TO: Mike Schulze, Cobblestone Denver
FROM: Stacey Nerger, Senior Planner
DATE: April 18, 2025
SUBJECT: Parker and Pine Filing No. 1 Lot 4 – Site Plan Amendment
Review Comments 01

PARKER AND PINE FILING NO. 1 LOT 4 - CAR WASH SITE PLANS

2 EXIT/SOUTH ELEVATION TRANSPARENCY DIAGRAM
1/8" = 1'-0"

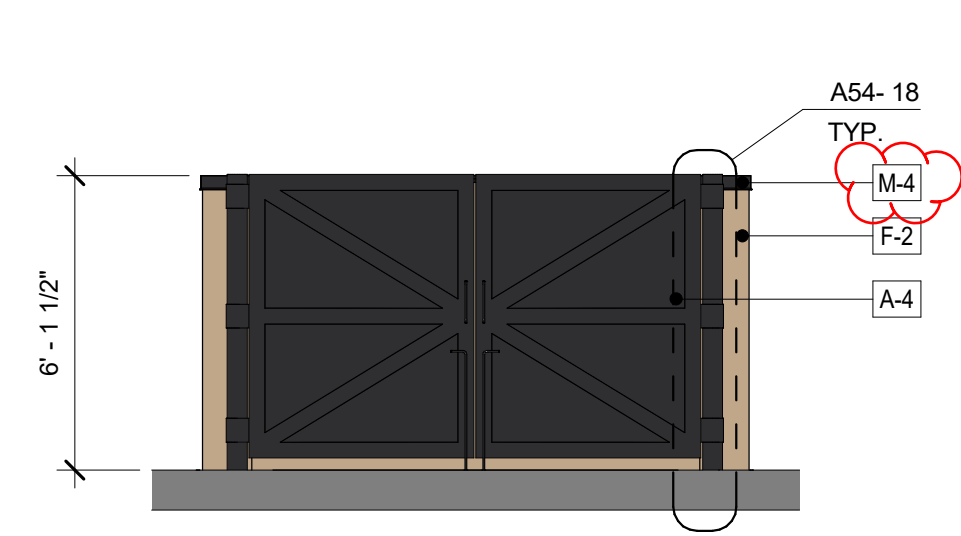
Additional colors, materials, elements are needed to meet the minimum design standards for the Town.

No edge or coping to finish the roof.

Unfinished elements (exposed wiring)

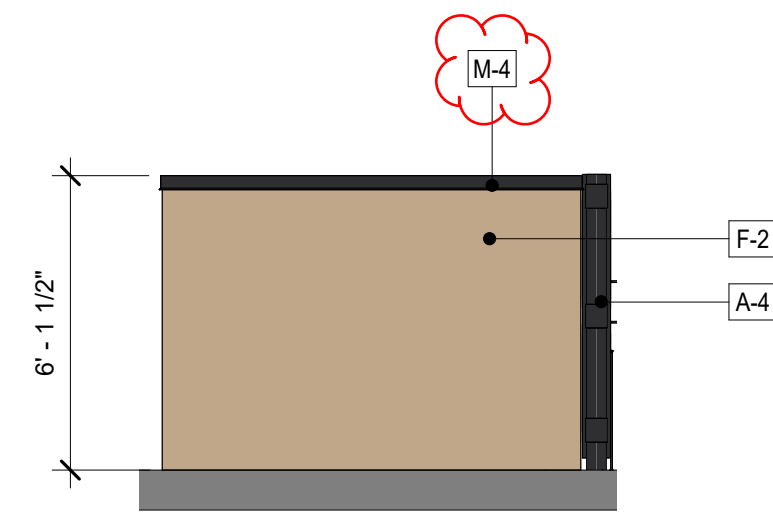
- 5. Accessory Buildings**
 - a. Accessory buildings or structures shall be located in the rear or on the side of a primary building.
 - b. Facades of accessory structures that are accessible to patrons or the general public shall be treated as building fronts and composed with openings, entries, building elements and detailing similar to those on the front of the building to which the building is accessory.
 - c. Accessory structures shall be designed in a similar style and palette as the primary buildings to which they are accessory.
 - d. Accessory buildings shall have the same setback as the primary building or setback a greater distance from the front of the primary building.
 - e. Drive-up ATMs shall have architectural fins or overhangs to create shelter for users.

The current color and material used for the canopy's is not consistent with the carwash building itself. In addition, the roof seems unfinished. There is not coping/finished edges along most sides of the roof. Other metal elements included as part of the site (awnings and roof) are curved and red in color. The metal coping around the roof is gray. Before Planning can sign off on the canopies, changes in design, materials, colors, etc. will be needed.

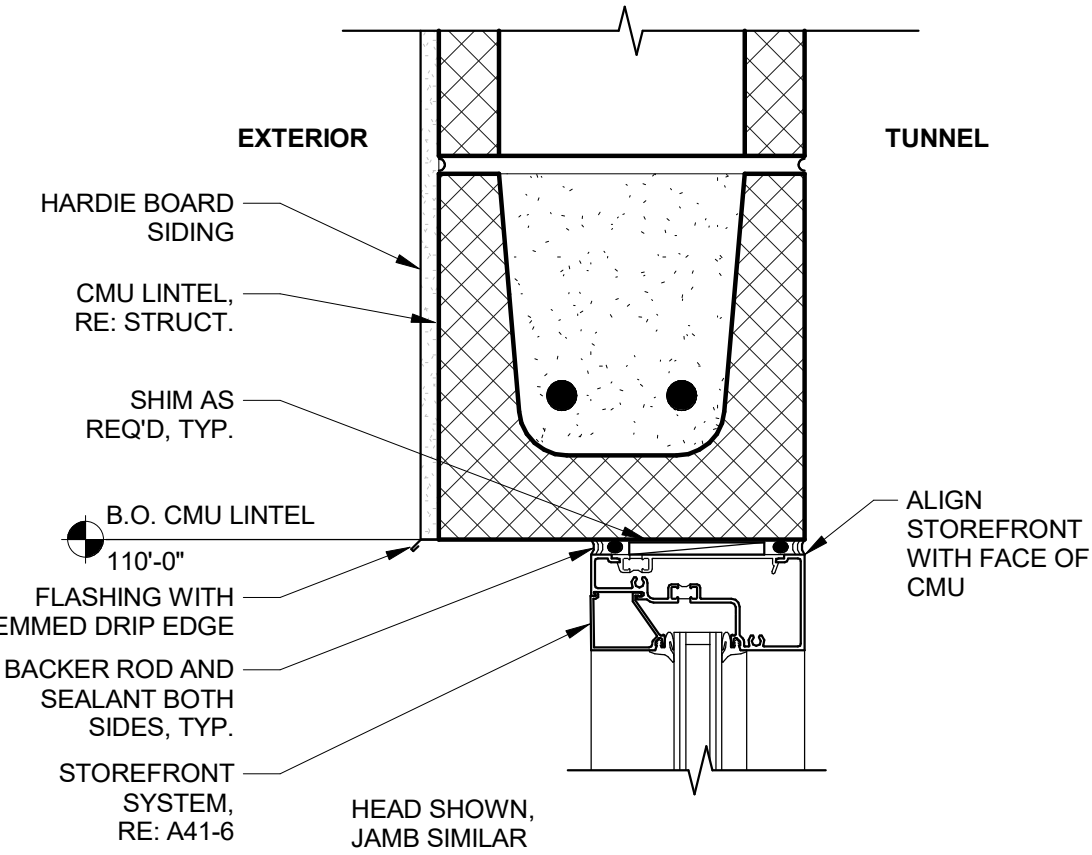
Check all items listed on Material and finish schedule for accuracy

10 SITE WALL ELEVATION
 1" = 1'-0"

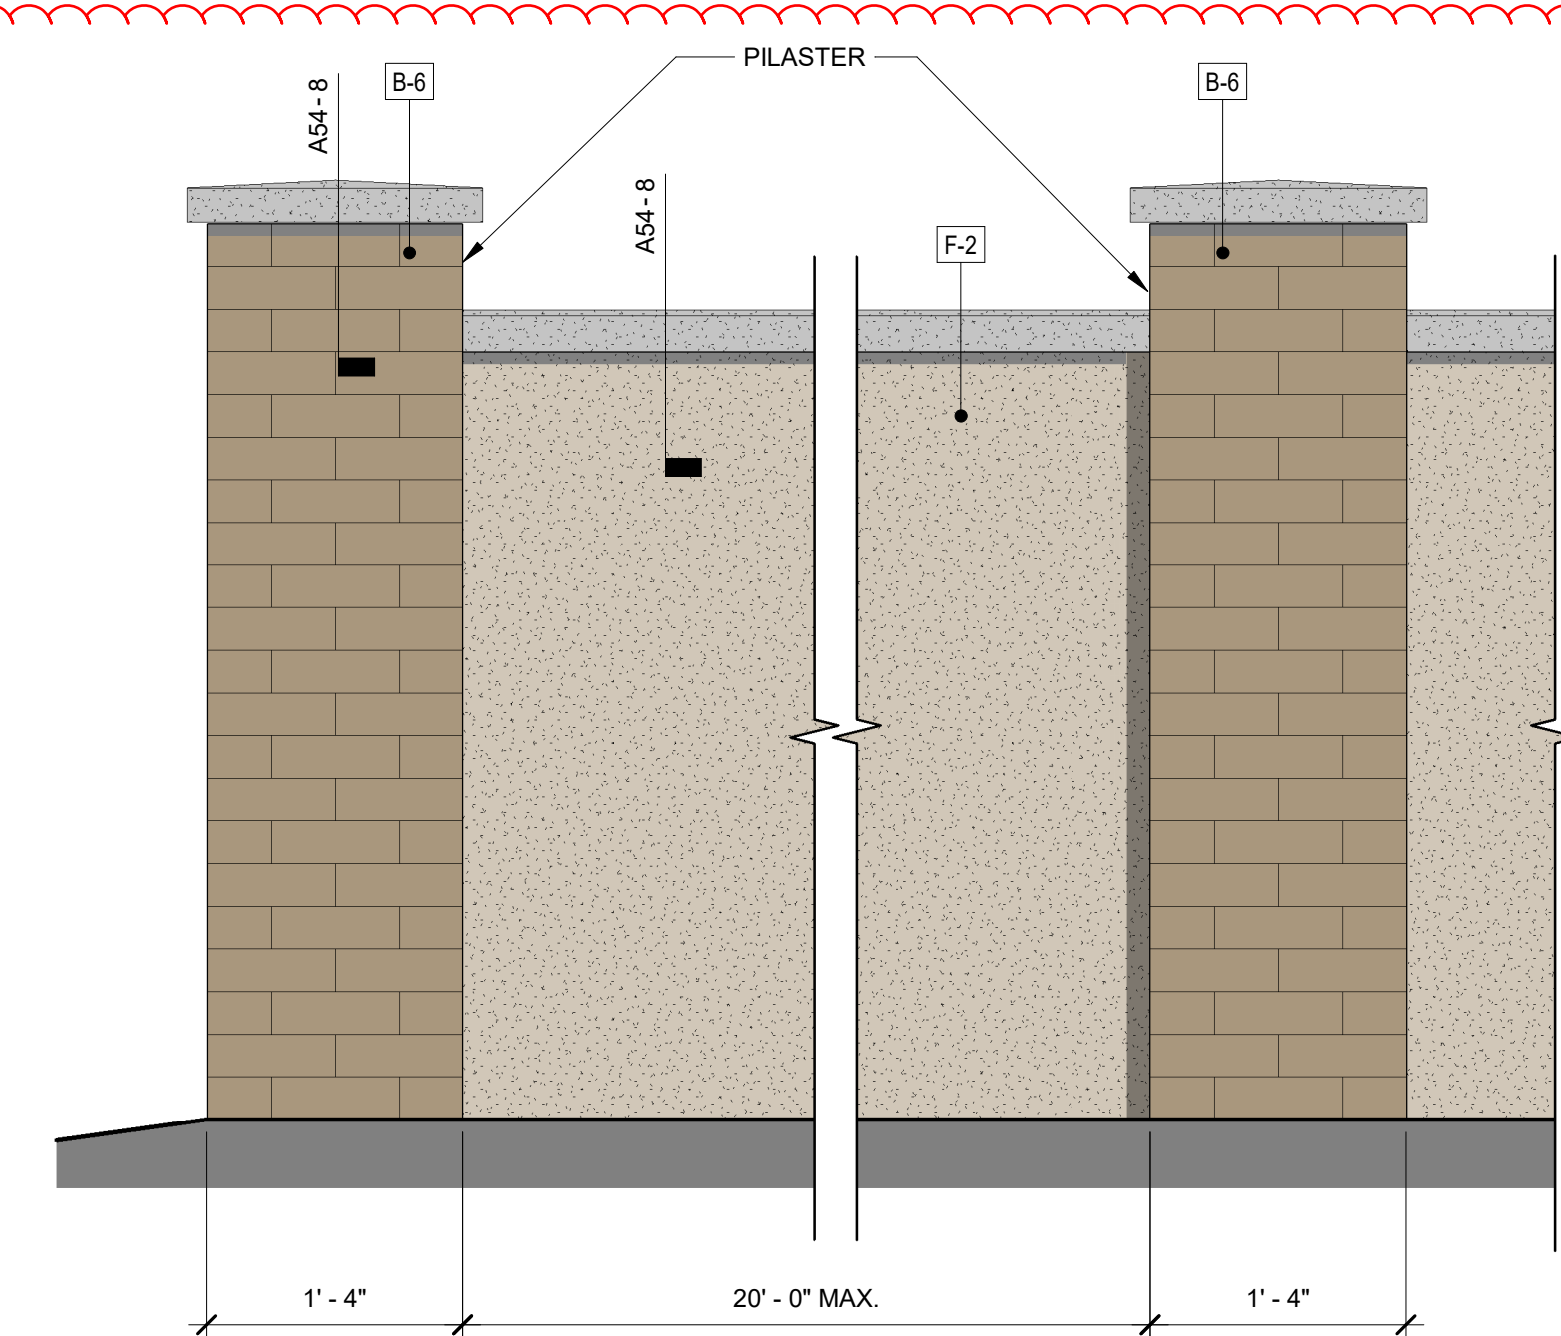
I don't believe that this site wall will be constructed. Instead exterior vacuum equipment will be wrapped in artwork. Please include an image of the proposed artwork.

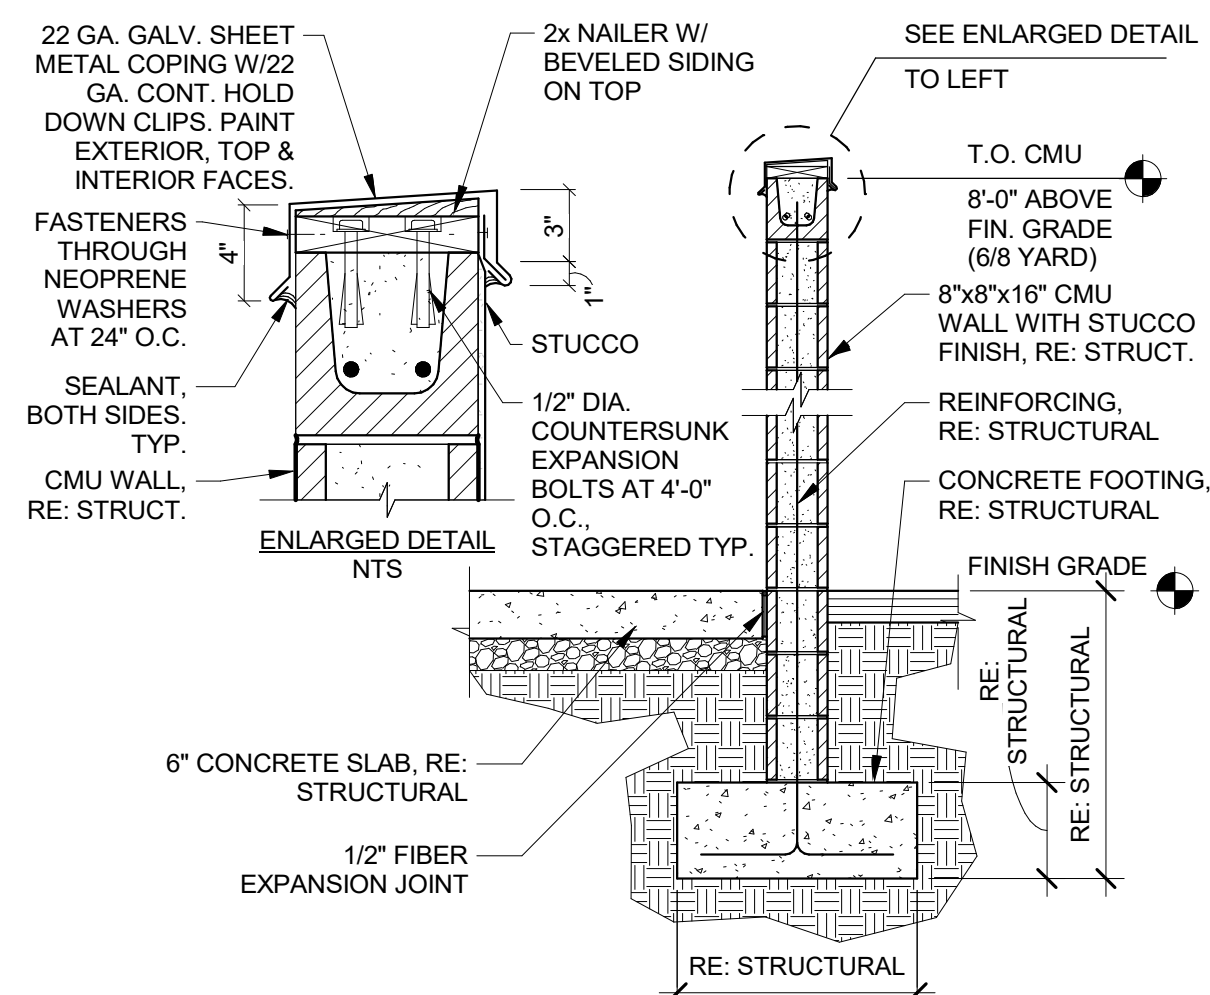
This is not what was installed. Please correct with the installed vacuums.

SHEET TITLE
**PHOTOMETRIC
SITE PLAN**

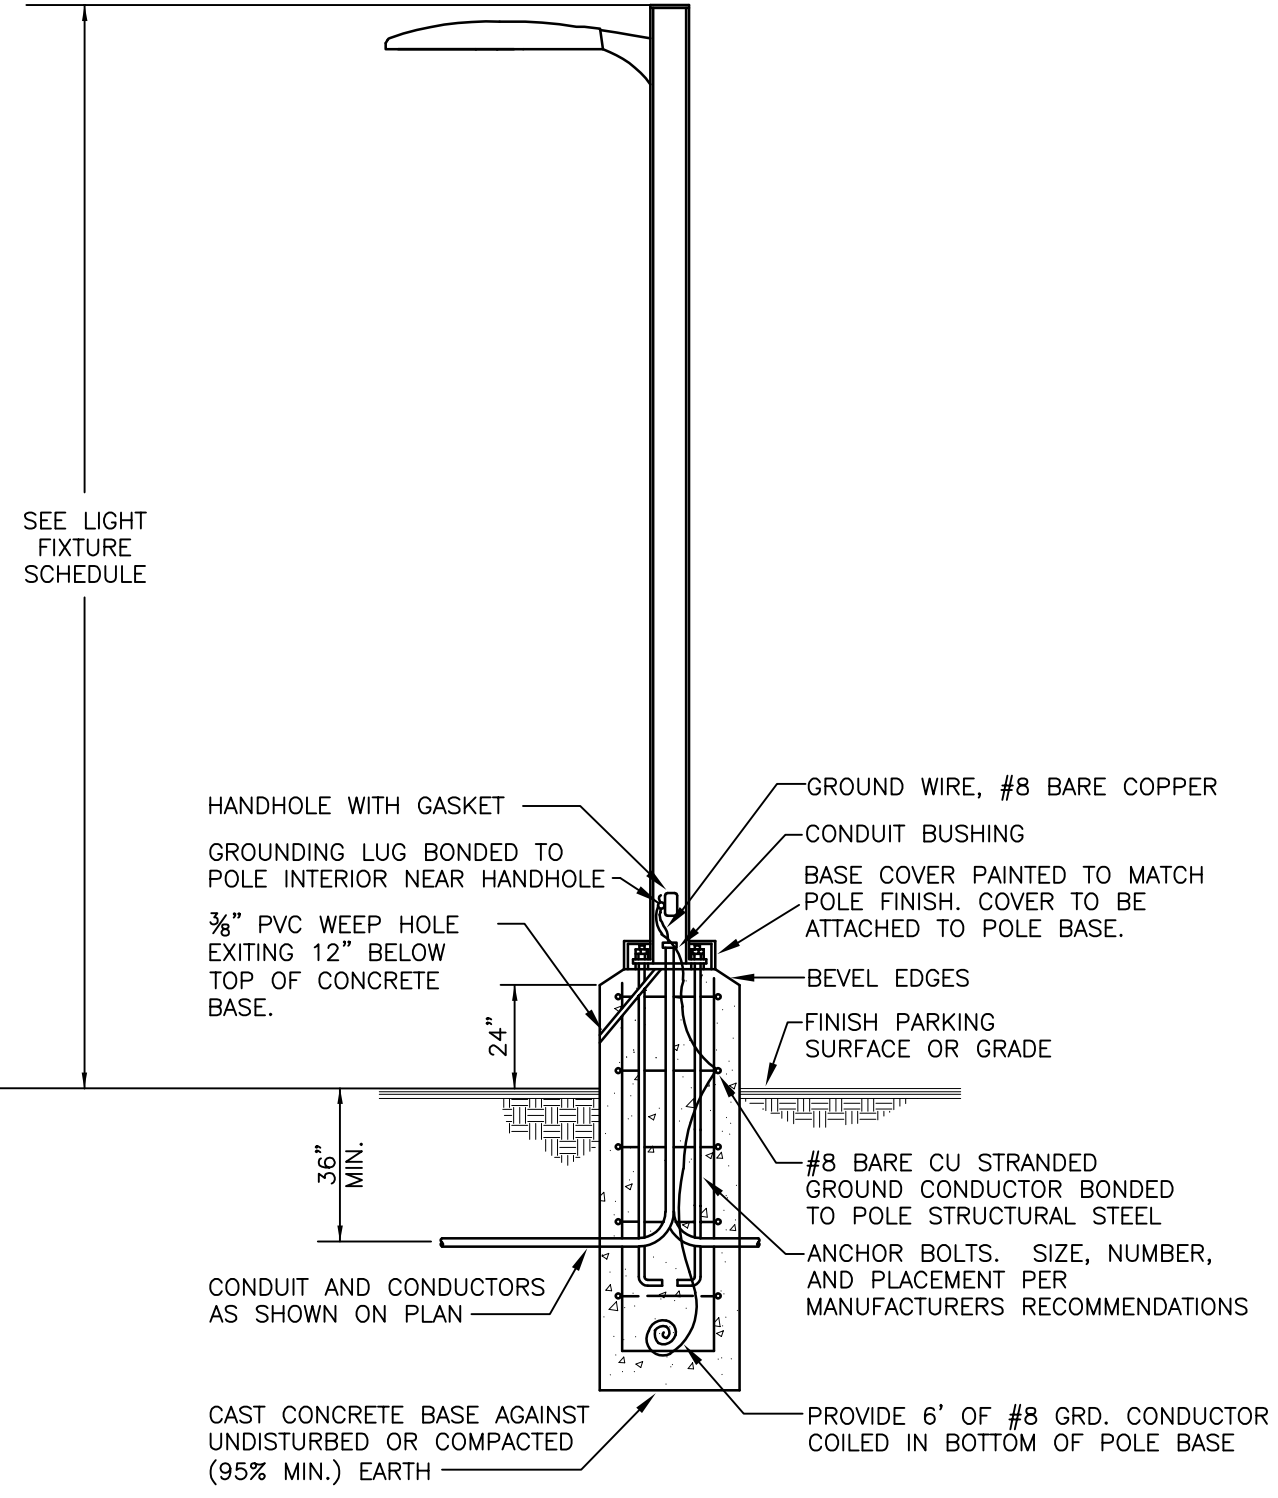
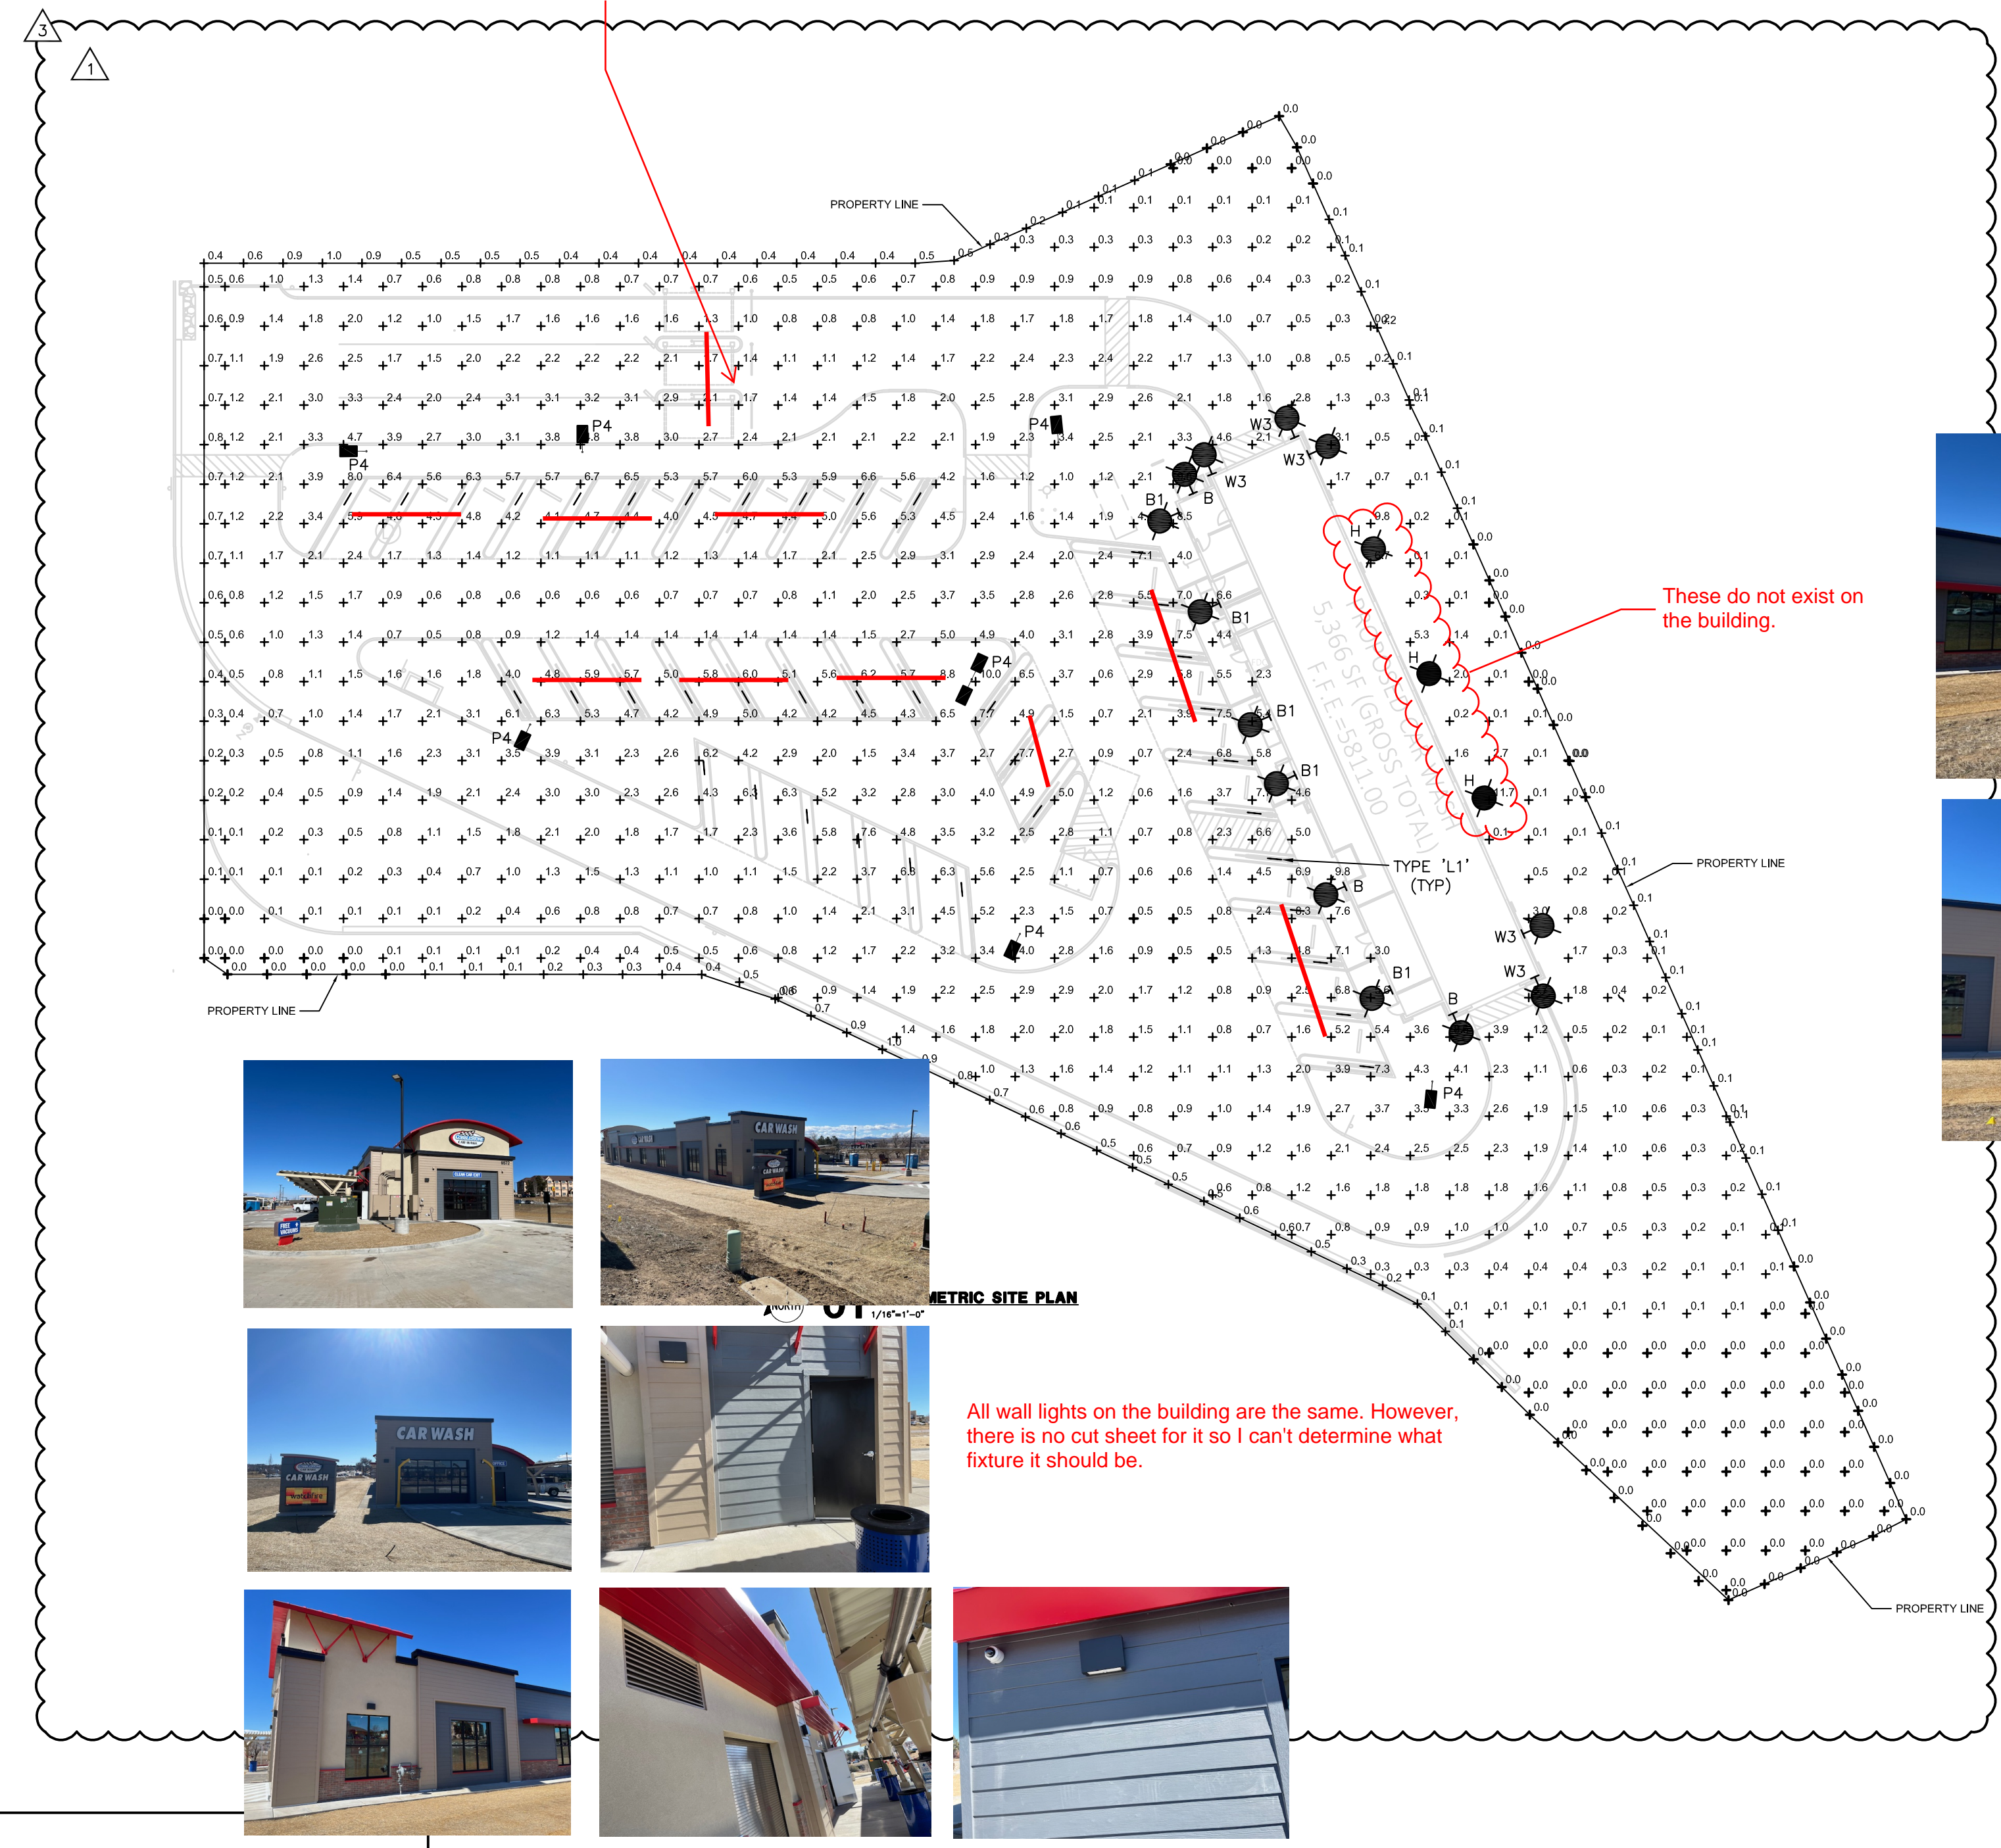
Lights have been added to the underside of the canopies. Please make sure these lights are included in this photometric and cut sheets are provided.

All wall lights on the building are the same. However, there is no cut sheet for it so I can't determine what fixture it should be.
